### **Technical Notification**

Document number: 97-131088

#### Condensation, Fleet Broadband antenna 3050A/C

Condensation in FBB antenna due to wrong installation.

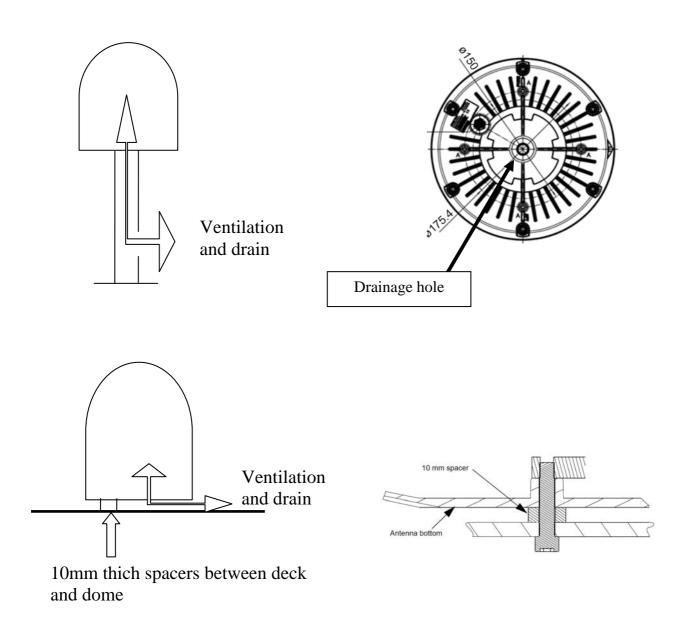
In some cases there will be condensation inside the radome. The gasket in the bottom center of the SAILOR 250-150 Fleet Broadband antenna is designed to lead any water away from the radome. Make sure this draining gasket is not blocked. If the antenna is mounted on a pole, make sure the pole is hollow inside and open at the bottom, allowing water from the gasket to escape and providing ventilation for the antenna

If the antenna is mounted on a flat surface, use 10 mm spacers (washers) at each bolt so that the gasket in the center of the antenna bottom is free and water can escape.

**Note:** The drainage holes at the center of the antenna must have a clearance of 10 mm above the base plane, and **must NOT be blocked.** Use spacers to "lift" the antenna. If the base plane is curved, it may be necessary to place extra spacers to ensure the clearance of 10 mm.
